Reference: Weber State University  
Shepherd Union Building Renovation & Remodel  
DFCM Project No. 03215810

Subject: **Addendum No. 1**

**Addendum No. One  
for the  
WSU Shepherd Union Building Renovation  
Demolition & Abatement  
DFCM Project No. 03215810  
MHTN Project No. 2005556**

ARCH REF:  
**ADD  
 1.01**

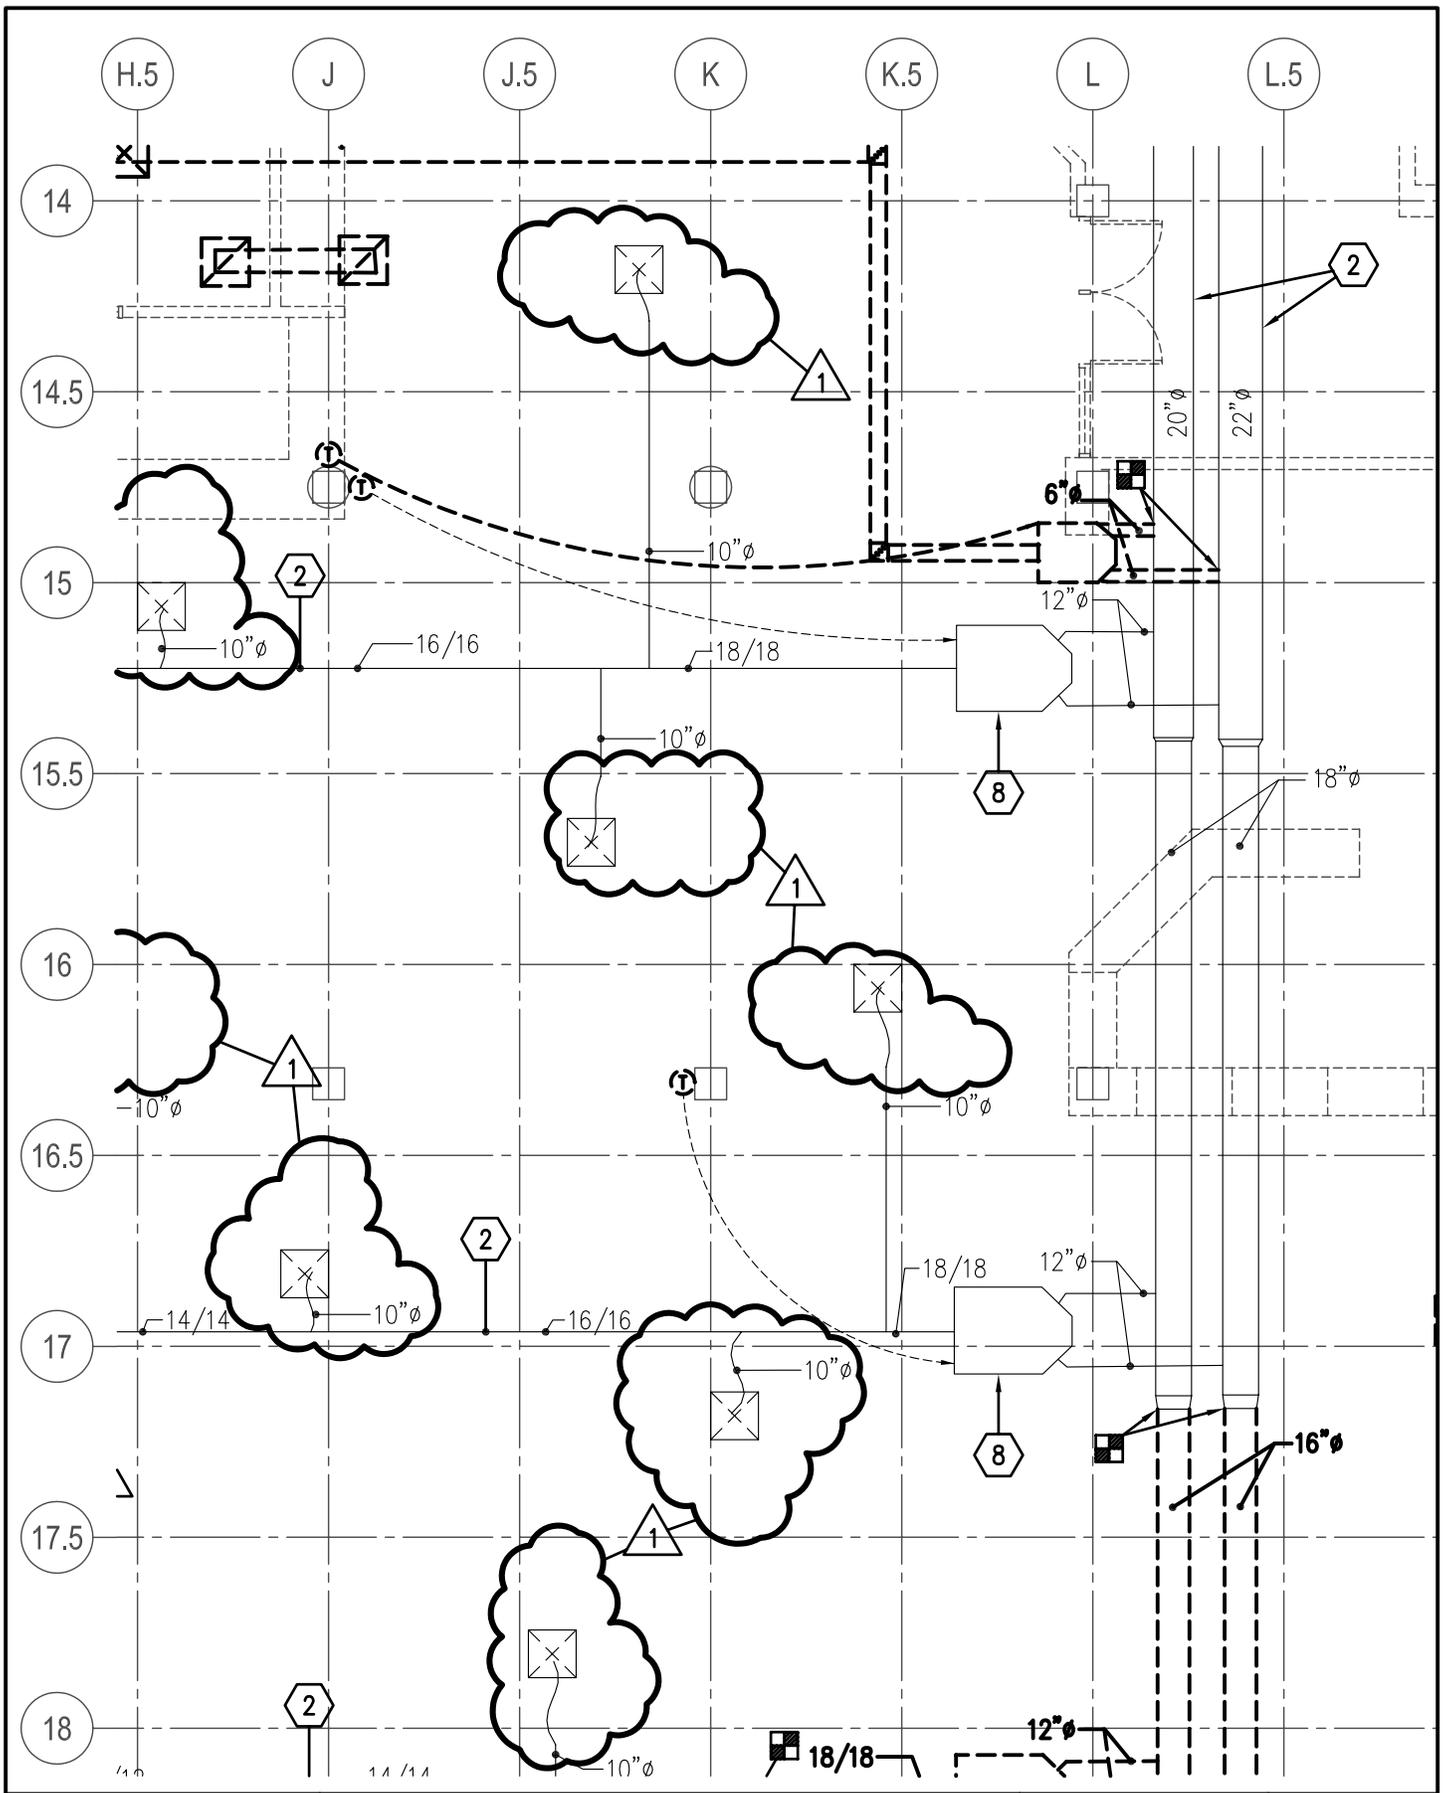
Sheet Title:  
**ADDENDUM #1  
 EXISTING DIFFUSERS TO REMAIN**

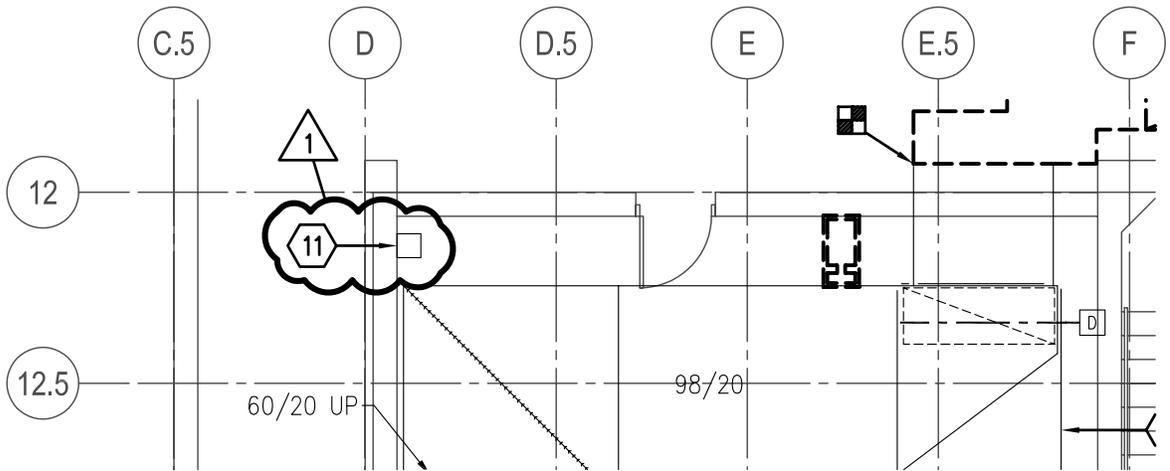
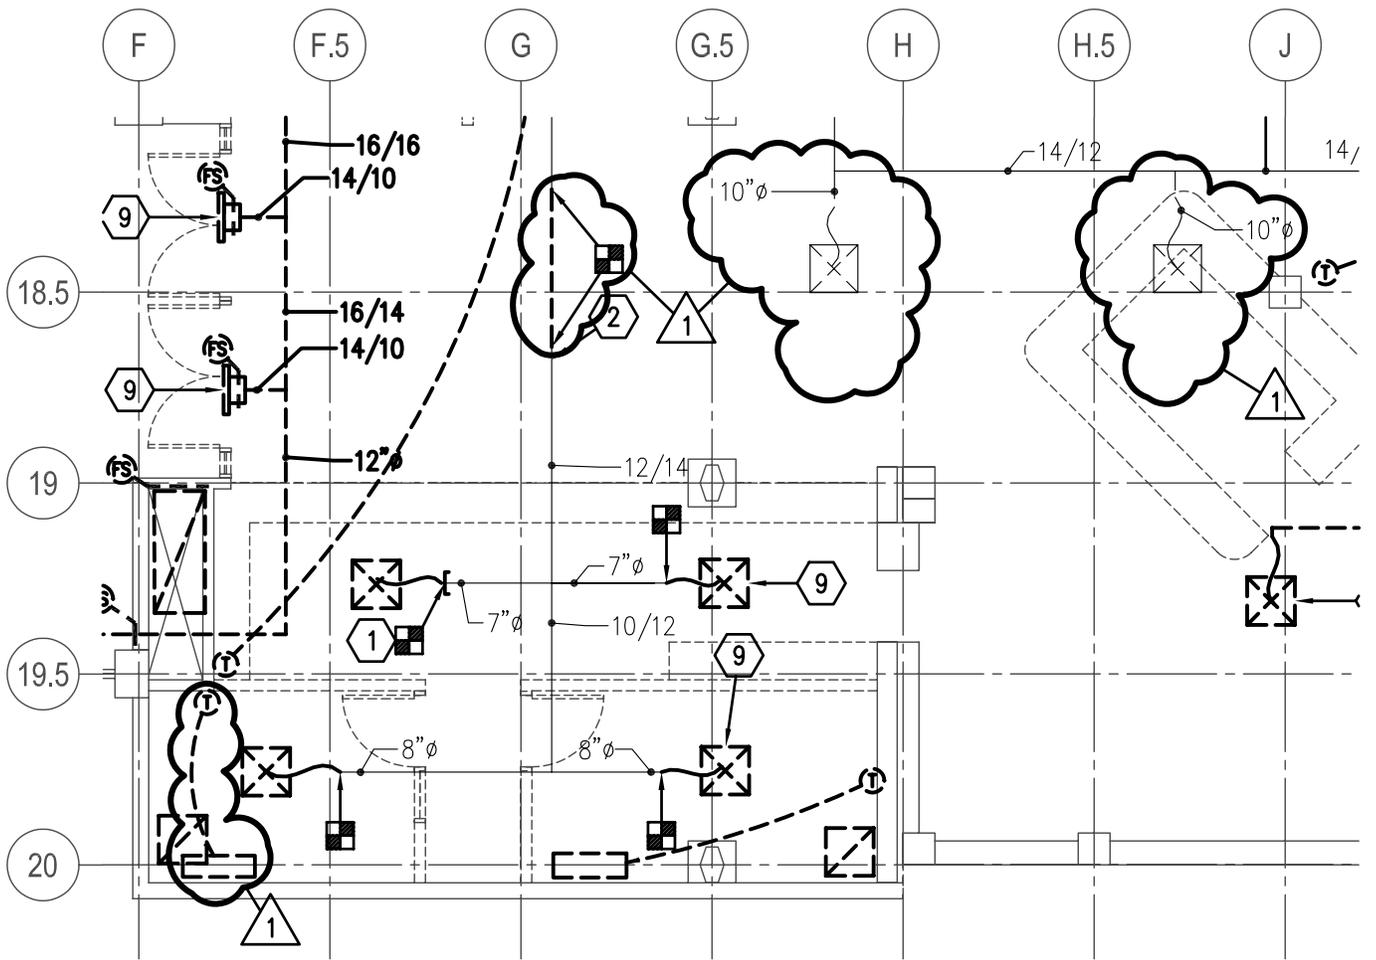
Project: <b>SHEPHERD UNION RENOVATION W.S.U.</b>	Sheet Title:	Date: 03-08-06	ARCH REF:
	<b>ADDENDUM #1 EXISTING DIFFUSERS TO REMAIN</b>	By: G. ROBERTS	
Original Sheet No: <b>DMH101.B</b>	 <b>Colvin Engineering Associates, Inc.</b> 244 West, 300 North, Suite 200 / Salt Lake City, Utah 84103-1108 (801) 322-2400 / Fax (801) 322-2416	Scale: 1/8" = 1'-0"	<b>ADD 1.02</b>
		Job No: 2005-041.00

ADD  
1.03

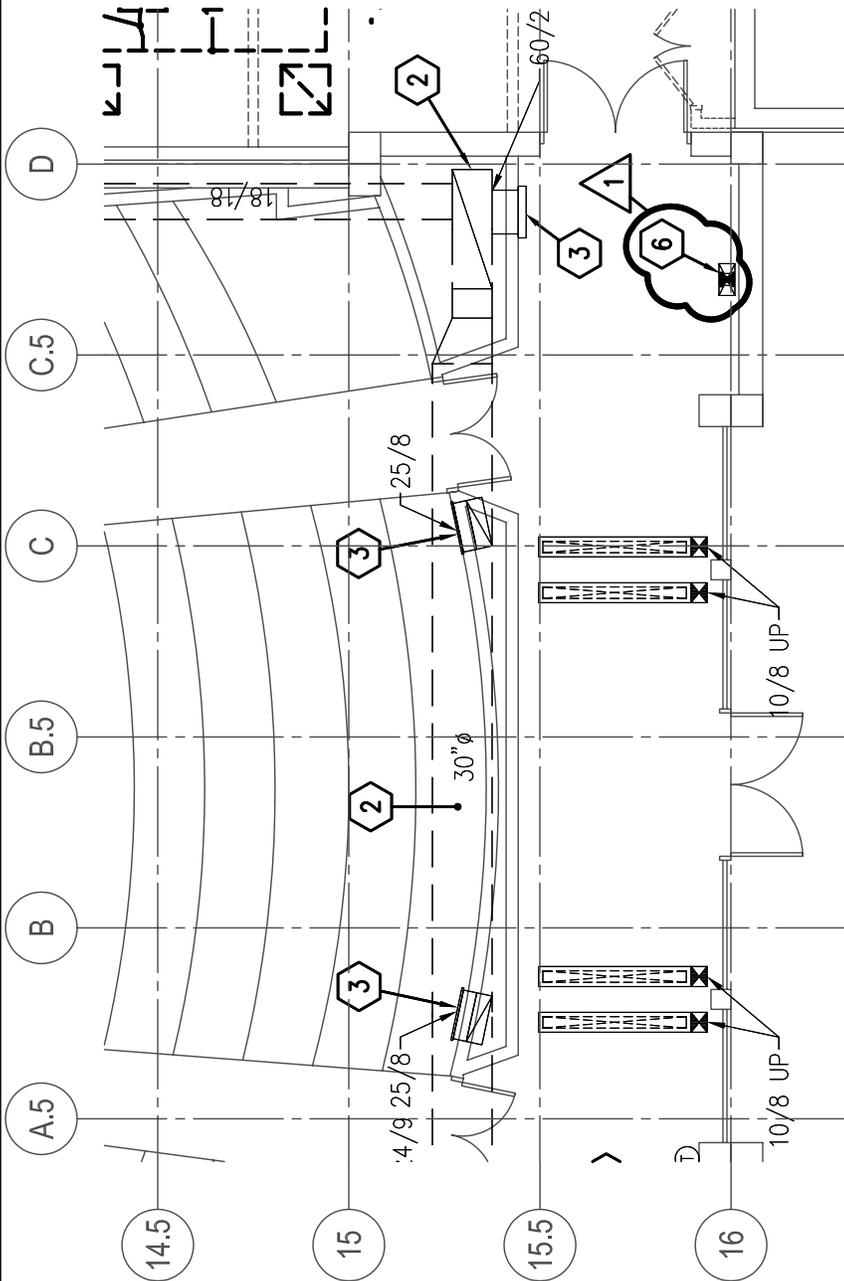
Sheet Title:  
ADDENDUM #1  
EXISTING VFD TO REMAIN

- 1 EXISTING RELIEF DUCT & LOUVER TO REMAIN.
- 2 EXISTING UNDER FLOOR RETURN AIR DUCT TO REMAIN.
- 3 EXISTING RETURN DUCT AND GRILLE TO REMAIN.
- 4 REMOVE EXISTING DOOR GRILLE.
- 5 REMOVE HOT AND COLD DUCTS UP AND DOWN THROUGH BUILDING.
- 6 REMOVE EXISTING DUCT UP THRU FLOOR, DIFFUSER TO REMAIN.

ADD  
1.04

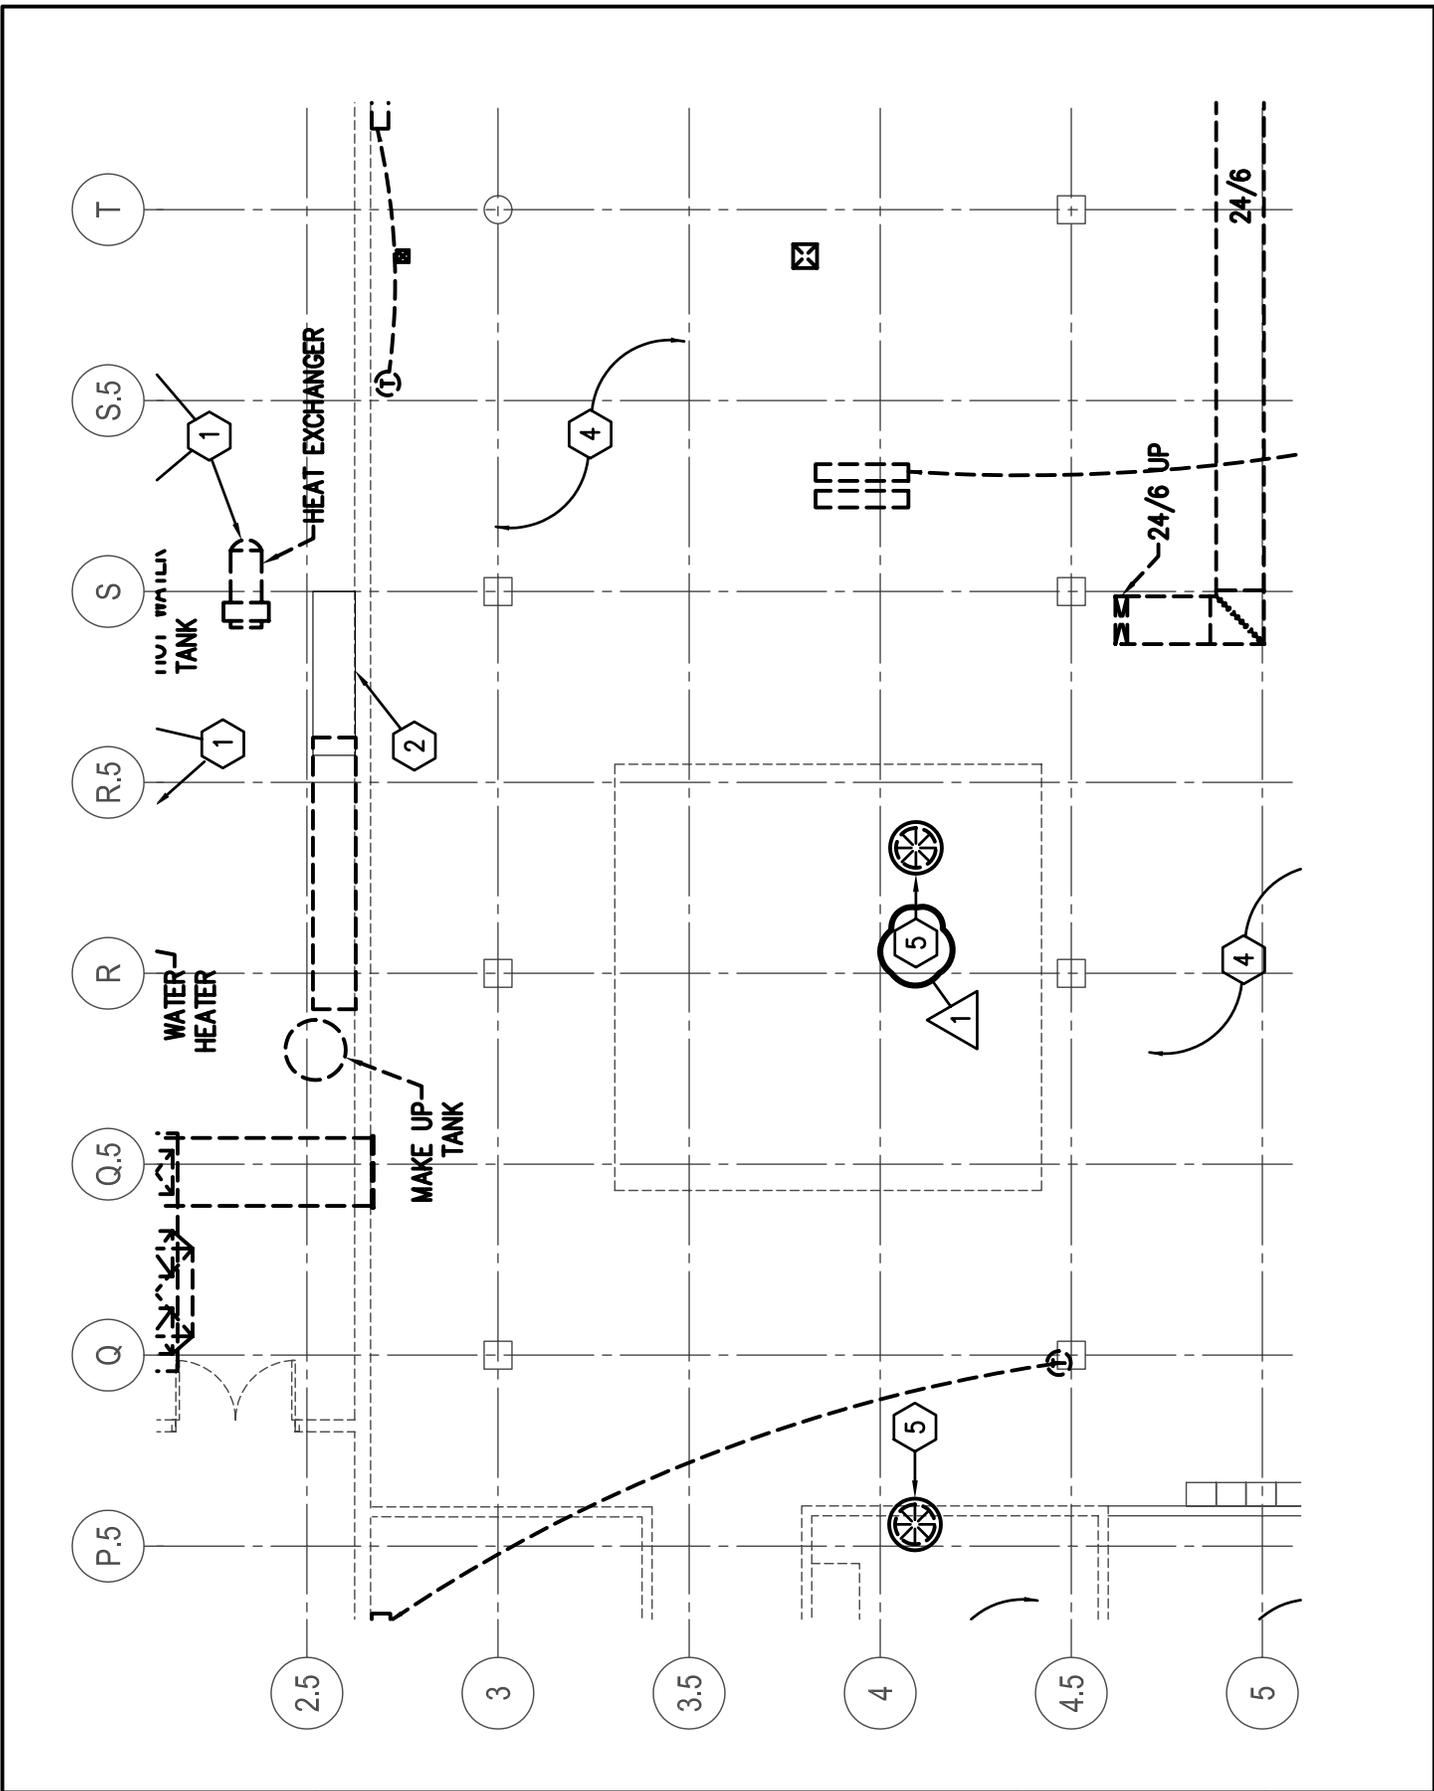
ADDENDUM #1  
KEYED NOTE CLARIFICATION ADD #6

ARCH REF:  
**ADD  
 1.05**

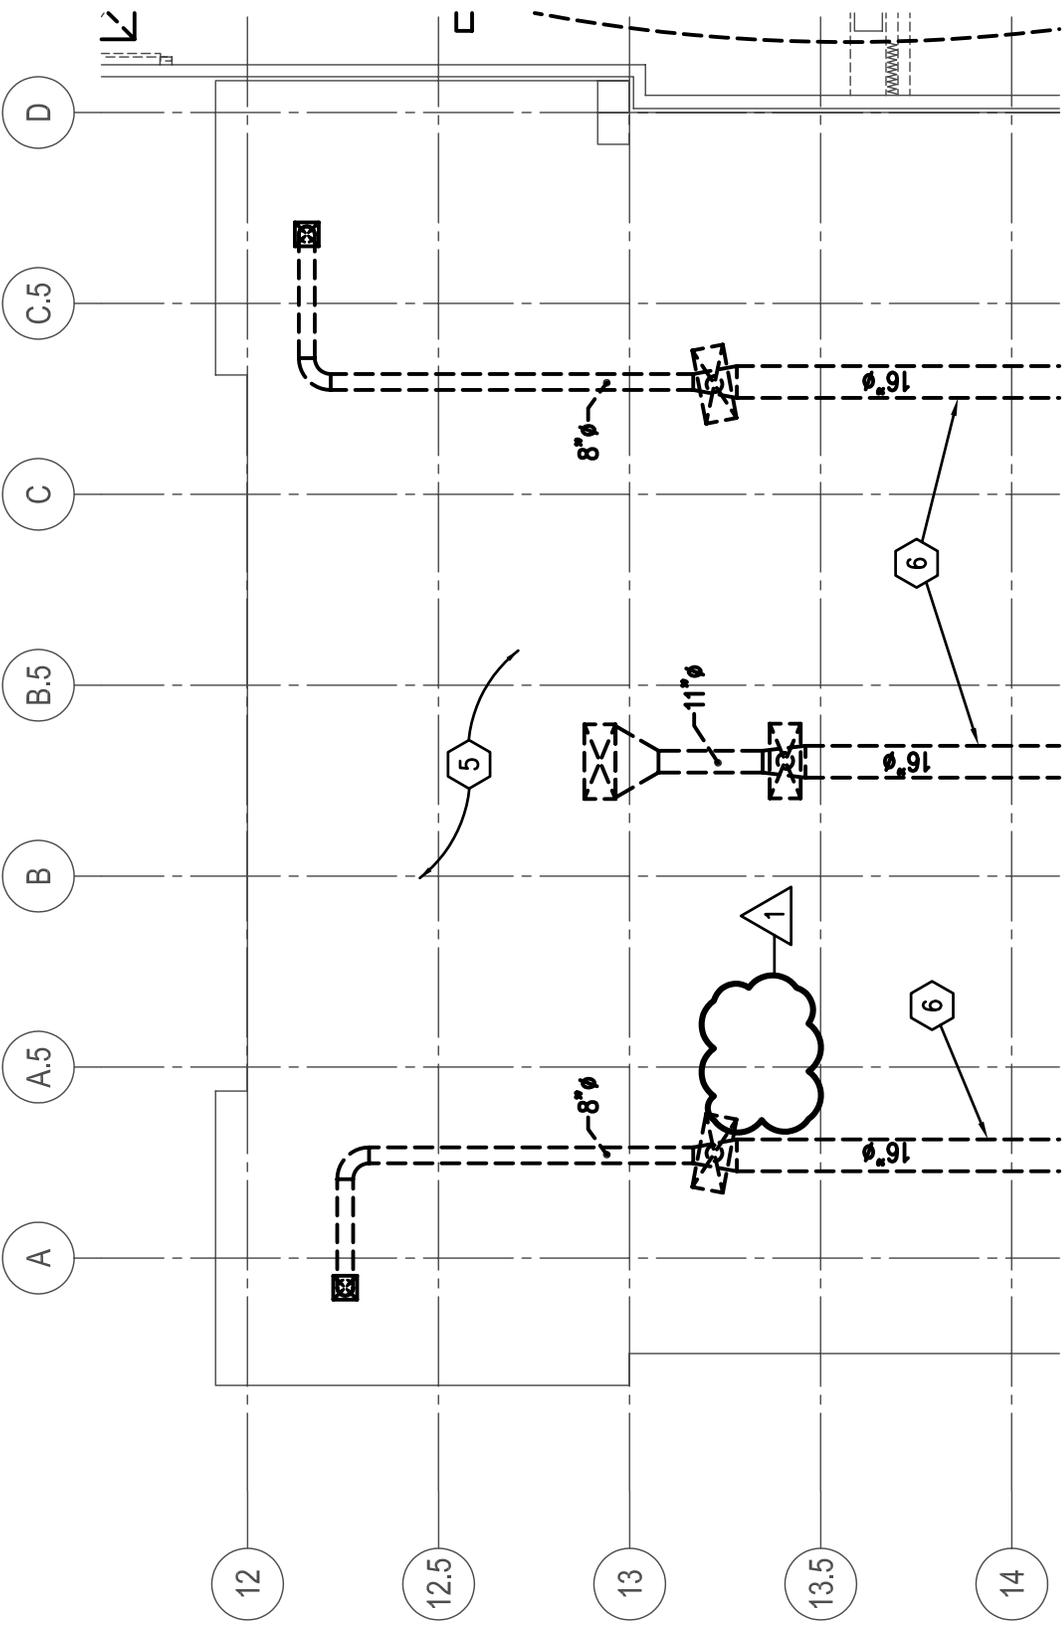
Sheet Title:  
**ADDENDUM #1  
 KEYED NOTE CLARIFICATION**
